Project	IEEE 802.16 Broadband Wireless Access Working Group < http://ieee802.org/16 >	
Title	Action Item from Session # 48: Credit token based coexistence protocol text update	
Date Submitted	2007-05-08	
Source(s)	David Grandblaise Motorola Labs Parc Les Algorithmes Commune de Saint Aubin 91193 Gif sur Yvette, France	Voice: +33 (0)1 6935 2582 Fax: +33 (0)1 6935 4801 mailto: david.grandblaise@motorola.com
Re:	Working Group Letter Ballot #24a for IEEE P80216h/D2a	
Abstract	During sessions # 48, several comments (2127, 2148L, 2149L, 2150L) were made to update and clean up text related to the credit token based coexistence protocol. This contribution provides some text remedy proposals for these comments to be included within IEEE 802.16h/D2a, and consolidates the previous preliminary contribution [3].	
Purpose	Action Item from Session # 48: Credit token based coexistence protocol text update	
Notice	This document has been prepared to assist IEEE 802.16. It is offered as a basis for discussion and is not binding on the contributing individual(s) or organization(s). The material in this document is subject to change in form and content after further study. The contributor(s) reserve(s)

Figure hc: Whole CT-CXP Procedure

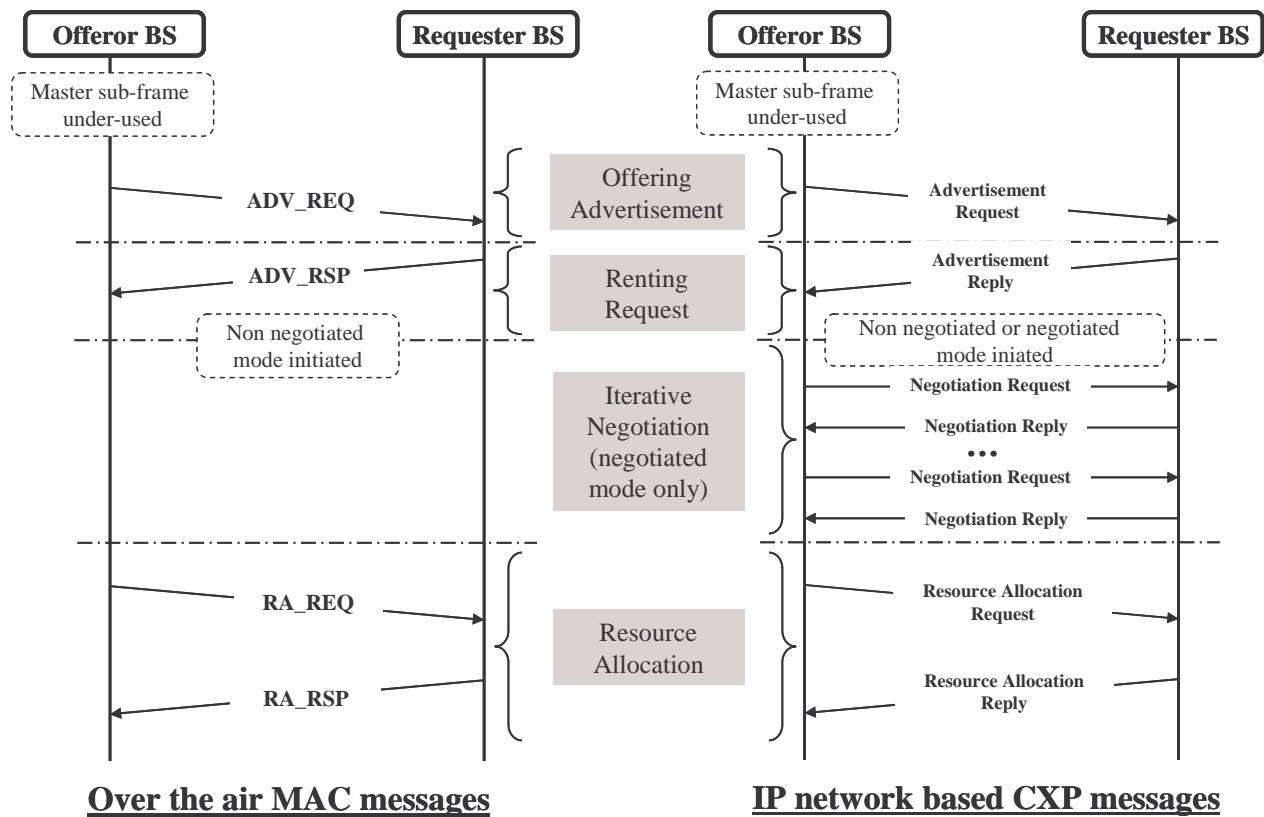
CT-CXP is composed of several consecutive procedures (offering advertisement, renting request, iterative negotiation, and resource allocation) as shown in Figure hc. For the sake of simplicity, this figure is only depicted for one (among multiple) requesters. Over the air based instantiation of CT-CXP for the non negotiated mode is depicted on the left hand side of Figure hc. The over IP network based instantiation of CT-CXP for the negotiation or non negotiated mode is depicted on the right hand side of Figure hc. MAC messages related to the over the air instantiation are specified in section 6.3.2.3. Inter system over the air communications mechanisms are described in subclause 15.x. CXP messages related to IP network based instantiation are specified in section 15.5.1. The offering advertisement message (Advertisement Request) specifies which negotiation mode is used by the CT-CXP. The iterative negotiation procedure is executed only with the negotiated mode and not with the non-negotiated mode.

Figure hd: Over the air based CT-CXP offering procedure

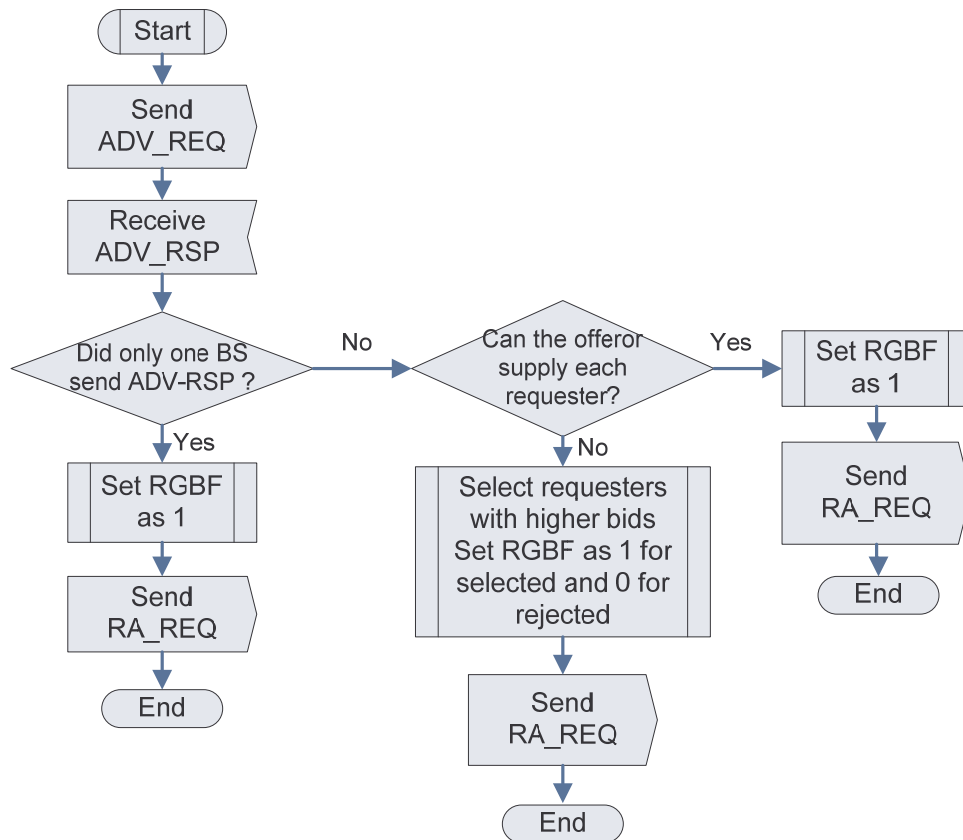
a) The procedure described in Figure hd is as follows:

- A BS identifies that a part of its master subframe is going to be under-used and can be rented out. With respect to this, this BS becomes an offeror BS and initiates the renting advertisement by broadcasting the ADV_REQ message. In particular, this message includes information related to the available resource (T_renting_subframe, Renting_out_start_time, Renting_out_end_time) as well as the renting conditions (MNCT: Minimum number of credit tokens per resource unit required per requester’s bid).

- If the offeror BS receives one single ADV_RSP message, then the offeror BS grants the renting resource to the single requester by setting the Resource Granting Bit Flag (RGBF) to 1 in the RA_REQ message. The granted requester is not charged with credit token since it is not competing with some other requesters.

- If the offeror BS receives more than one ADV_RSP message, then it assesses whether he can supply each requester or not:
 - If it can supply, the offeror BS grants the renting resource to all requesters by setting the Resource Granting Bit Flag (RGBF) to 1 in the RA_REQ message.

- If it cannot, the offeror BS derives and selects requesters with higher bids based on the information received from competing requesters. The offeror BS grants the resource to the selected requesters by setting the Resource Granting Bit Flag (RGBF) to 1 in the

RA_REQ message. These selected requesters can access to their requested resource (Rented_resource_amount) during the guaranteed requested time period (Renting_in_start_time, and Renting_in_end_time). RGBT is set to 0 for the non selected requesters.

- The RA_REQ message includes the clearing price (Clearing_price) mentioning the number of credit tokens the requester has to freeze to acquire the granted resource.

Figure he: IP network based CT-CXP offering procedure

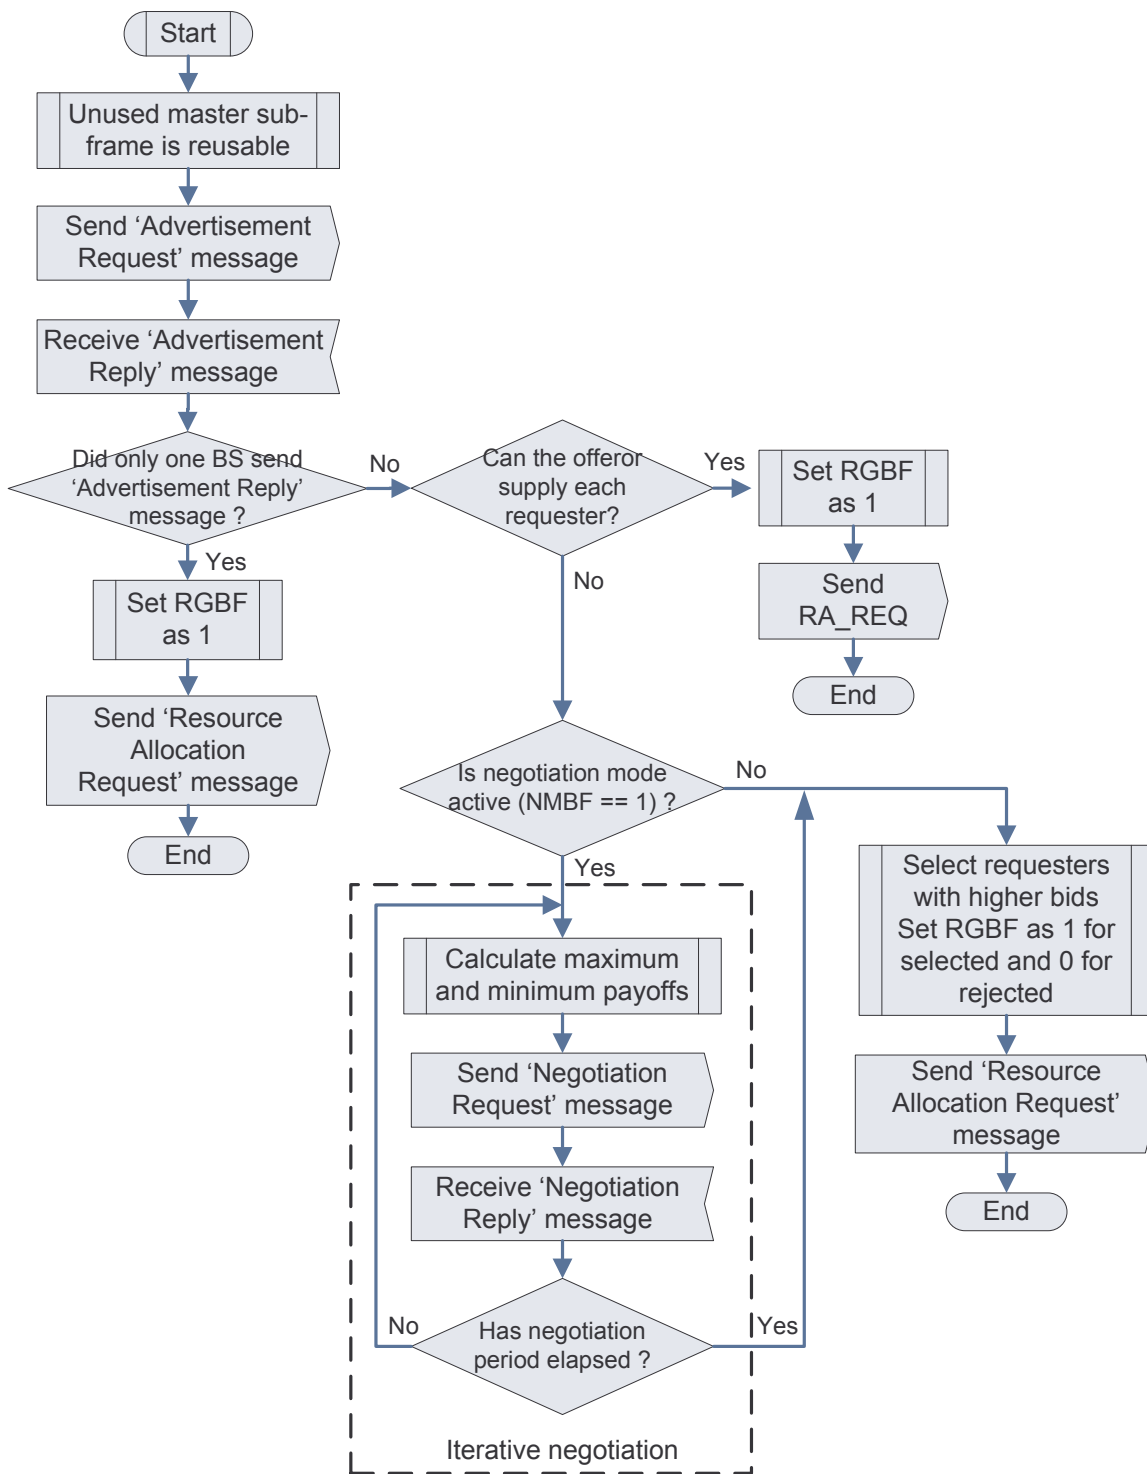
b) The procedure described in Figure he is as follows:

- A BS identifies that a part of its master subframe is going to be under-used and can be rented out. With respect to this, this BS becomes an offeror BS and initiates the renting advertisement by broadcasting the “Advertisement Request” message. In particular, this message includes information related to:

- The available resource (T_renting_subframe, Renting_out_start_time, Renting_out_end_time),
 - The negotiation mode (NMBF == 0: non negotiated mode is active, NMBF == 1: negotiated mode is active),

- The renting conditions (Start_negotiation_time, End_negotiation_time, MNCT),
 - The pricing method in case NMFF == 1.
- If the offeror BS receives one single “Advertisement Request” message, then the offeror BS grants the renting resource to the single resquester by setting the Resource Granting Bit Flag (RGBF) to 1 in the “Resource Allocation Request” message. The granted requester is not charged with credit token since it is not competing with some other requesters.

- If the offeror BS receives more than one “Advertisement Request” message, then it assesses whether he can supply each requester or not:
 - If it can supply, the offeror BS grants the renting resource to all requesters by setting the Resource Granting Bit Flag (RGBF) to 1 in the “Resource Allocation Request” message.

- If it cannot, the offeror BS follows the negotiated mode under consideration:
 - If NMBF == 0, same procedure as a) is executed. The Offeror BS derives and selects requesters with higher bids based on the information received from competing requesters. The offeror BS grants the resource to the selected requesters by setting the Resource Granting Bit Flag (RGBF) to 1 in the “Resource Allocation Request” message. These selected requesters can access to their requested resource (Rented_resource_amount) during the guaranteed requested time period (Renting_in_start_time, and Renting_in_end_time). RGBT is set to 0 for the non selected requesters.

- If NMBF == 1, iterative negotiation occurs between the offeror BS and each requester BS. Based on the information received within the “Advertisement Reply” message, the offeror BS calculates respectively a minimum and maximum payoff (Minimal_payoff and Maximal_payoff) at each iteration. These payoffs allow selecting the remaining requesters at each iteration. An example of payoff calculation is given in section 15.4.2.4.2. At each iteration, Minimal_payoff and Maximal_payoff are sent within the “Negotiation Request” message. The iterative negotiation occurs until the negotiation period (bounded by End_negotiation_time) is elapsed. At the end of the negotiation, the final requesters are selected by the offeror BS. The offeror BS grants the resource to the selected requesters by setting the Resource Granting Bit Flag (RGBF) to 1 in the “Resource Allocation Request” message. These selected requesters can access to their requested resource (Rented_resource_amount) during the guaranteed requested time period (Renting_in_start_time, and Renting_in_end_time). RGBT is set to 0 for the non selected requesters.

Figure hf: Over the air based CT-CXP requesting procedure

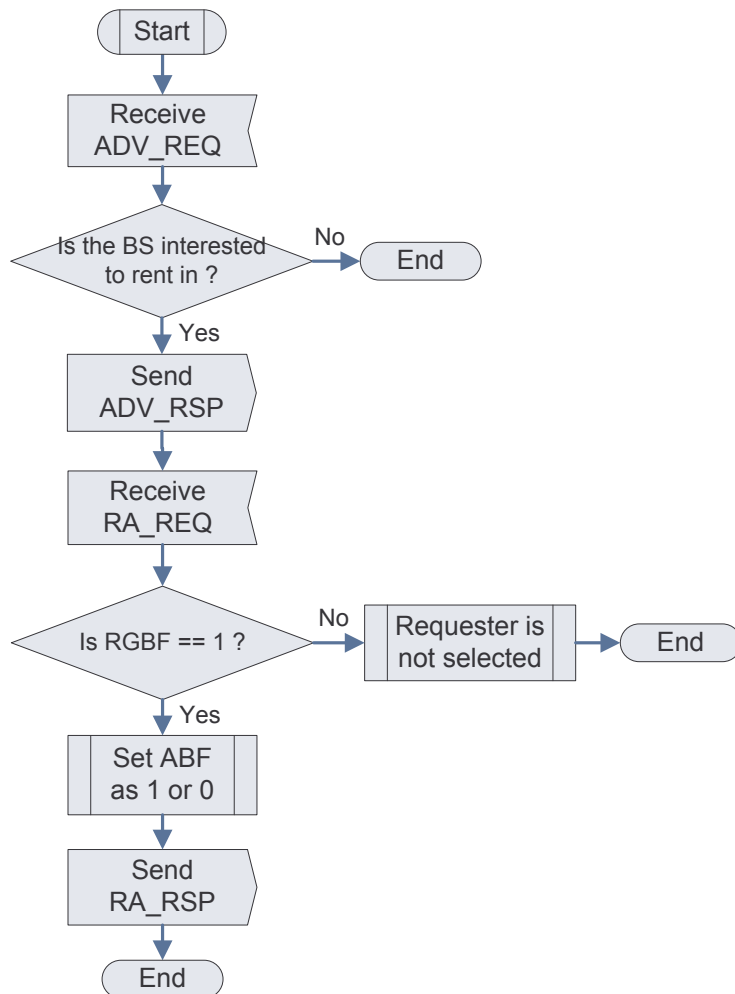
a) The procedure described in Figure hf is as follows:

- If a BS is in need of additional resource and can meet MNCT requirements, he can make a request (ADV_REQ message) upon the reception of ADV_REQ.
- Within ADV_RSP, the requester informs about the amount of required resource (Rented_resoure_amount), the rented in start and end time (Renting_in_start_time, Renting_in_end_time) and the requester’s bid (Requester_bid) in term of number of credit tokens bidded per resource unit.

- Upon reception of RA_REQ message, the requester BS knows whether it has been selected or not. If RGBF is set to 1, the requester BS is selected, otherwise (RGBF set to 0) the requester is rejected.

- The requester decides to accept (Acceptation Bit Flag ABF set to 1) or to reject (ABF set to 0) the resource granting based on the Clearing_price information. This information is sent within the RA_RSP message.

- If ABF is set to 1, a number of credit tokens equal to the clearing price will not be usable (for some other renting requests by this requester) for a time duration equal to [renting_in_start_time; renting_in_end_time + δ] where δ is a frozen period margin. This ensures fairness over time between competing requester BSs to access to some other renting offers.

Figure hg: IP network based CT-CXP requesting procedure

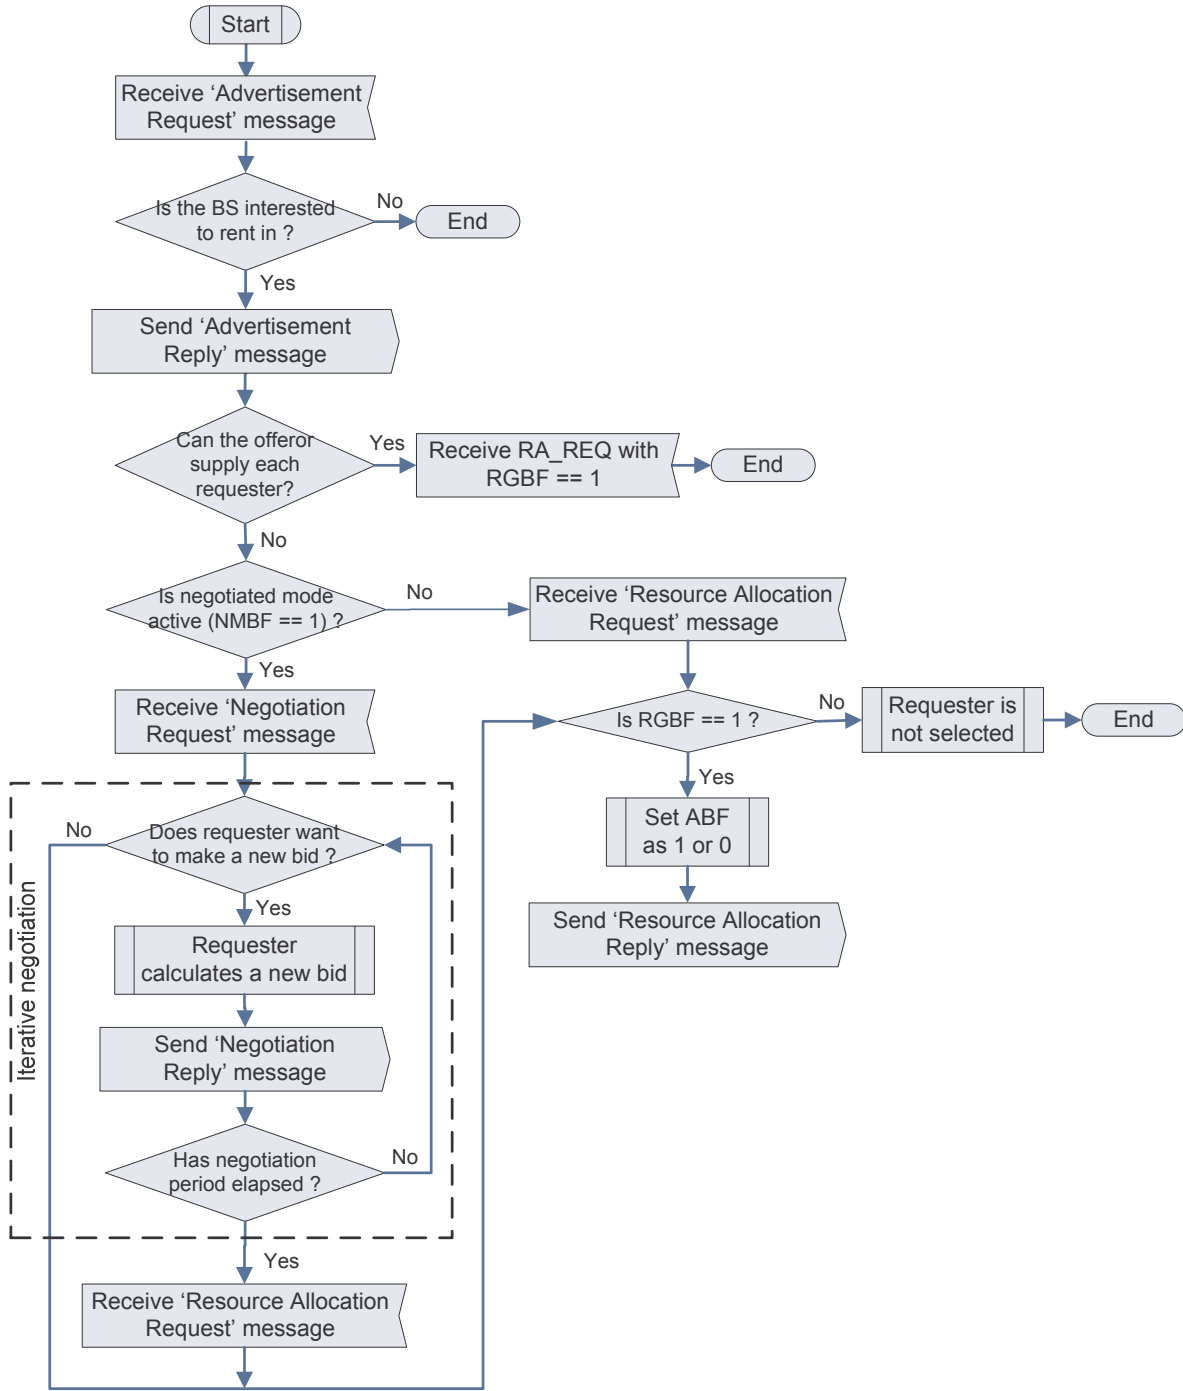
b) The procedure described in Figure hg is as follows:

- If a BS is in need of additional resource, meets MNCT requirements, and agree with the proposed negotiation mode (NMBF) and pricing method (PBF) specified within the “Advertisement Request” message, he can submit a bid (“Advertisement Reply” message) upon the reception of the “Advertisement Request” message.

- Within the “Advertisement Reply” message, the requester informs about the amount of required resource (Rented_resource_amount), the rented in start and end time (Renting_in_start_time, Renting_in_end_time) and the requester’s bid (Requester_bid) in term of number of credit tokens bid per resource unit.

- If the non negotiation mode is active (NMBF == 0), same procedure as a) is executed. If the offeror BS can supply to the requester BS, the offeror BS grants the renting resource by setting the Resource Granting Bit Flag (RGBF) to 1 in the “Resource Allocation Request” message.

- If the negotiation mode is active (NMBF == 1), iterative negotiation occurs between the offeror BS and each requester BS. At each iteration, based on the information Minimum_payoff and Maximal_payoff received from the “Negotiation Request” message, the requester decides to submit a new bid (Requester_bid_update) or not. Requester_bid_update is sent within the “Negotiation Reply” message. The iterative negotiation occurs until the negotiation period (bounded by End_negotiation_time) is elapsed.

- Upon reception of the “Resource Allocation Request” message, the requester BS knows whether it has been selected or not. If RGBF is set to 1, the requester BS is selected, otherwise (RGBF set to 0) the requester is rejected.

- The requester decides to accept (Acceptation Bit Flag ABF set to 1) or to reject (ABF set to 0) the resource granting based on the Clearing_price information. This information is sent within the “Resource Allocation Reply” message.

- If ABF is set to 1:
 - If PBF == 0, a number of CTs equal to the $\text{Clearing_price} \times \text{Rented_resource_amount} \times \text{T_renting_subframe} \times (\text{Renting_in_end_time} - \text{Renting_in_start_time}) / \text{CX_Frame_duration}$ is transferred from the requester’s ownership to the offeror’s one.

- If PBF == 1, the CT are not transferred but remains to the requester ownership. However, a number of credit tokens equal to the clearing price will not be usable (for some other renting requests by this requester) for a time duration equal to $[\text{renting_in_start_time}; \text{renting_in_end_time} + \delta]$ where δ is a frozen period margin. This ensures fairness over time between competing requester BSs to access to some other renting offers.

Figure h69—Architecture for coexistence of BWA and preferred radio applications

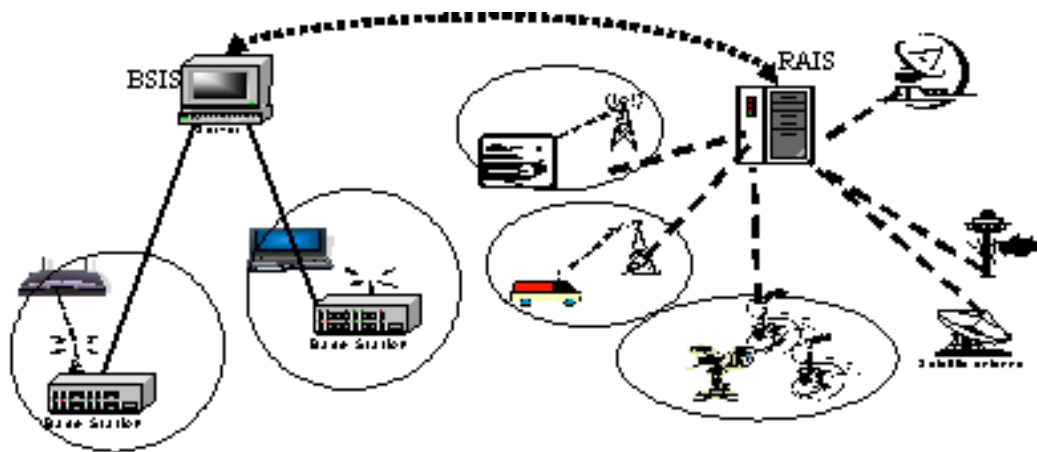
In addition to these functions, this architecture can also serve for the administration of the credit tokens to be used for the CT-CXP operations. For that purpose, RAIS can specify to BSISs some policies (ruling) for the usage of the credit tokens for the BS covered by this BSIS. For example, polices can specify the number of credit tokens to be assigned to each BS at some given locations or some given time periods, the negotiation mode, the pricing method, and so forth. The BSIS communication with RAIS is supported by the Coexistence Protocol messages Regulatory Authority Request and Regulatory Authority Response.
